National Academies of Sciences – Supplemental LAW Options

October 2021

Jeff Burright
Oregon Department of
Energy

Technical questions/comments on the FFRDC Annotated Outline Draft

Figure 5-5. Baseline Case – Total Single-Shell Tank Retrievals Completed per Calendar Year.

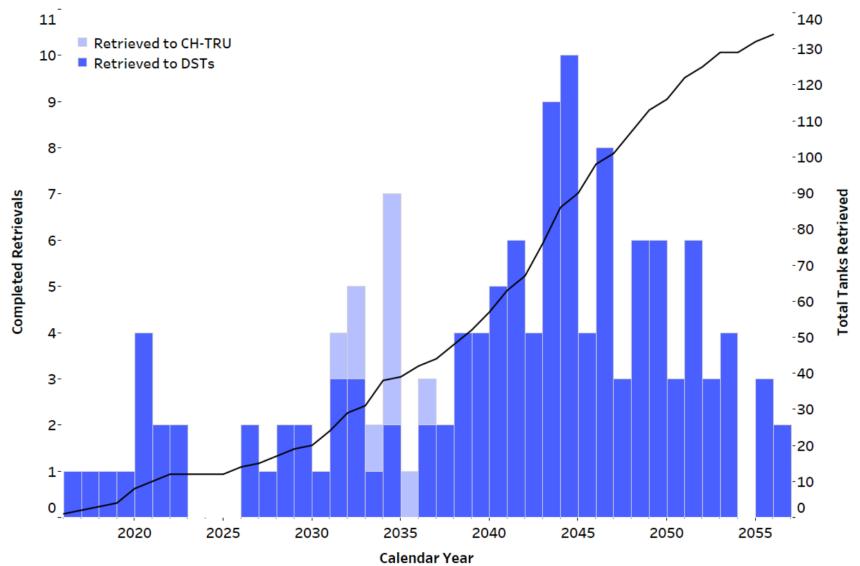
- Comparative performance categories good organization
- "Potential new tank leaks" full SLAW grout alternative not required to address this risk. Potentially a false choice.
 - Include a sub-alternative where interstitial liquids are retrieved early shipped offsite?
 - Significant inventory in interstitial liquid from SRS experience.
 - HAB subcommittee considering possible benefits of early interstitial liquid retrieval + Test Bed Initiative concept of at-tank treatment and offsite grout.
- Mixing in DSTs incorrectly referred as "baseline" (TWCS facility)
- When does SST retrieval rate become the limiting factor?
